## Executive Director's Recommendation

<b>PROJECT</b> <b>Building 245 Radiation Physics Laboratory Rehabilitation and Addition</b> National Institute of Standards and Technology 100 Bureau Drive Gaithersburg, Maryland	<b>NCPC FILE NUMBER</b> 7893
<b>SUBMITTED BY</b> United States Department of Commerce National Institute of Standards and Technology	<b>NCPC MAP FILE NUMBER</b> 3115.10(38.00)44600
<b>REVIEW AUTHORITY</b> Federal Projects in the Environs per 40 U.S.C. § 8722(b)(1)	<b>APPLICANT'S REQUEST</b> Approval of final site and building plans
	<b>PROPOSED ACTION</b> Approve final site and building plans
	<b>ACTION ITEM TYPE</b> Consent Calendar

## NIST BUILDING 245 B/C WING ADDITION

### RESPONSES TO NOTES FROM NCPC DATED 13 JULY 2017

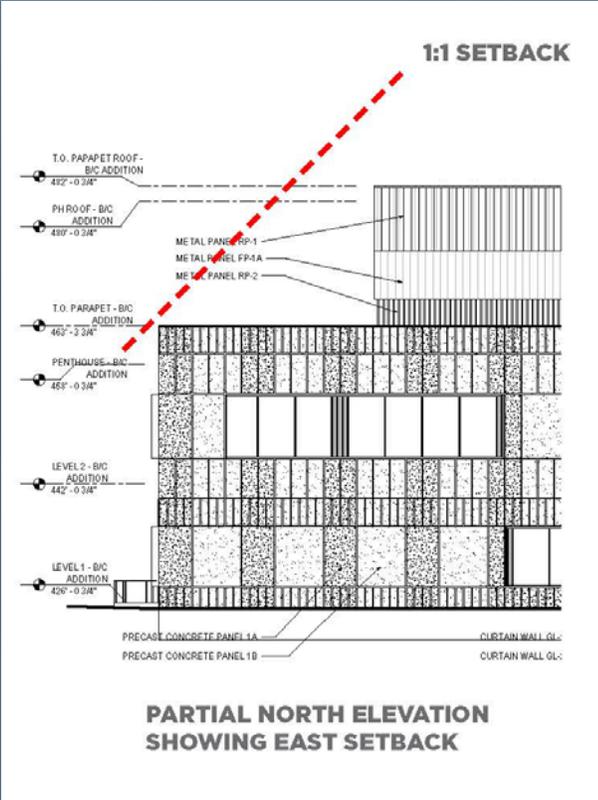
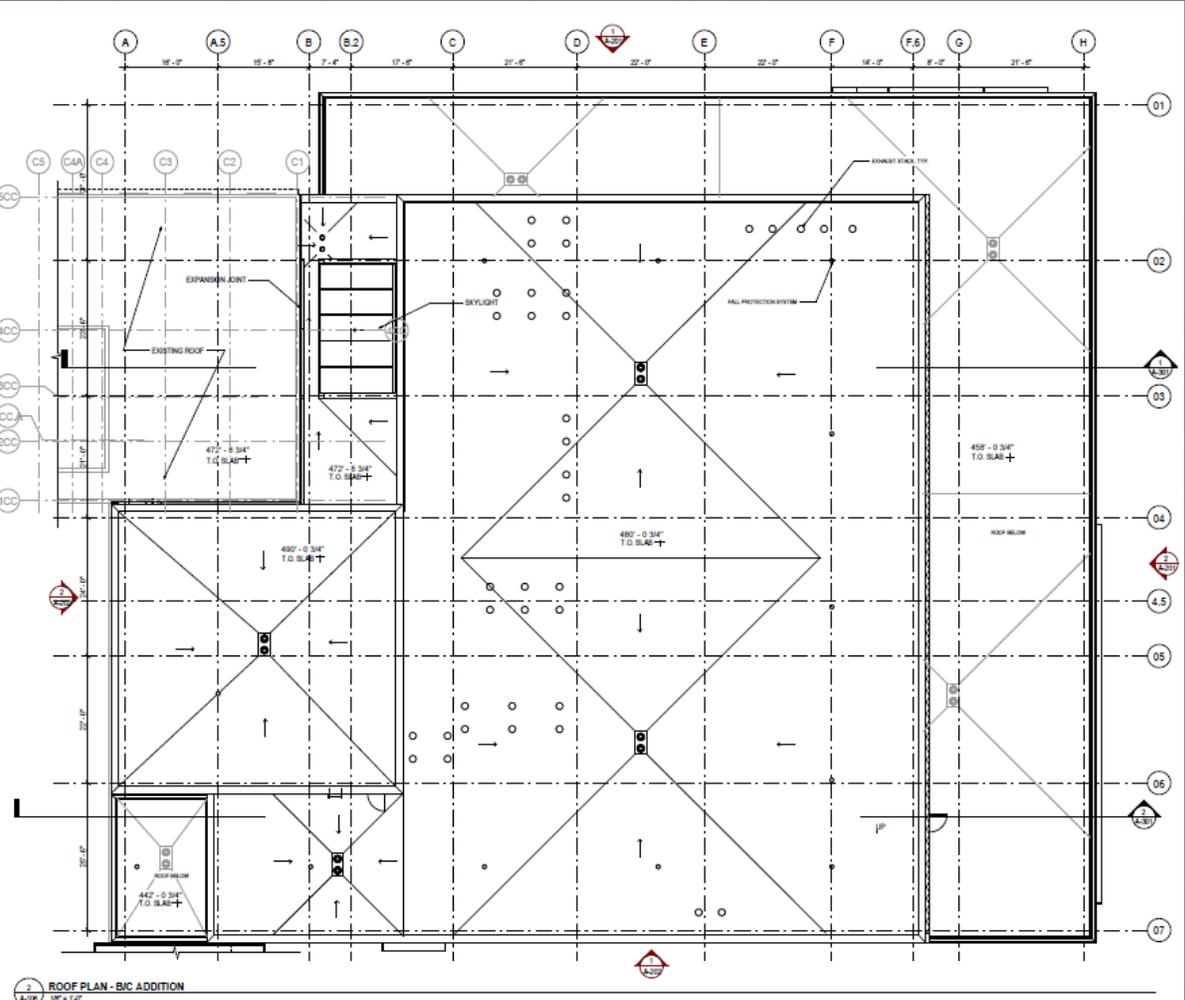
- Reduce the height and mass of the penthouse enclosures, and setback the penthouse from all exterior walls a distance greater than or equal to their height.

- Ensure that all mechanical equipment is screened and not visible on the roof, including exhaust stacks.

The penthouse is set back by a 1:1 or greater ratio on the two primary facades, north and east, as indicated in the diagrams on attached page 3. The west façade abuts the existing building, and the south façade abuts the loading dock. The penthouse volume has been reduced during the design process but, due to the highly technical nature of the radiation research inside Building 245, and the need for new systems to replace vastly outdated ones from the 1960s, it is not possible to reduce further.

All mechanical equipment is enclosed within the conditioned penthouse, per NIST requirements, excepting the stacks, which must extend upward through the roof in order to provide for the safe and code-mandated dispersal of lab exhaust air. As this requirement is common in scientific research buildings, the proposed stacks will relate visually and functionally to many similar ones nearby on the NIST campus. Pages 4-5 show several examples.

**PARTIAL NORTH ELEVATION SHOWING EAST SETBACK**

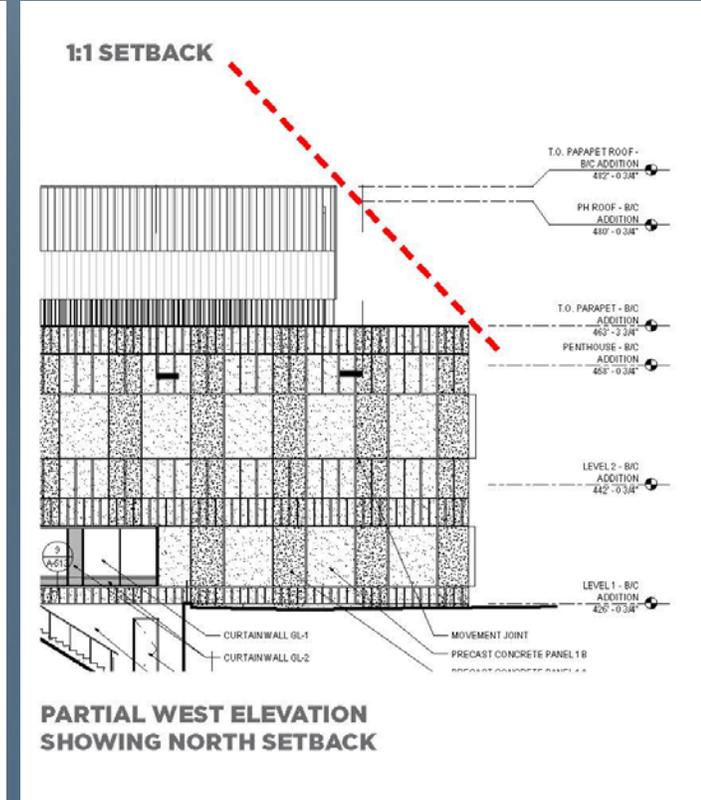
- Reduce the height and mass of the penthouse enclosures, and setback the penthouse from all exterior walls a distance greater than or equal to their height.

The penthouse is set back by a 1:1 or greater ratio on the two primary facades, north and east, as indicated in the diagrams on attached page 3. The west façade abuts the existing building, and the south façade abuts the loading dock. The penthouse volume has been reduced during the design process but, due to the highly technical nature of the radiation research inside Building 245, and the need for new systems to replace vastly outdated ones from the 1960s, it is not possible to reduce further.

# NIST Campus Exhaust Stack Location Map

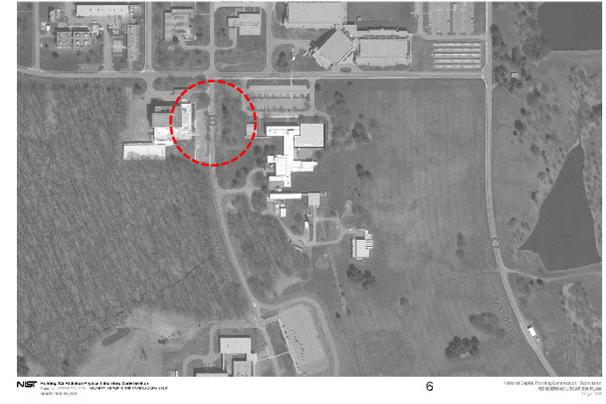
- Ensure that all mechanical equipment is screened and not visible on the roof, including exhaust stacks.

All mechanical equipment is enclosed within the conditioned penthouse, per NIST requirements, excepting the stacks, which must extend upward through the roof in order to provide for the safe and code-mandated dispersal of lab exhaust air. As this requirement is common in scientific research buildings, the proposed stacks will relate visually and functionally to many similar ones nearby on the NIST campus. Pages 4-5 show several examples.
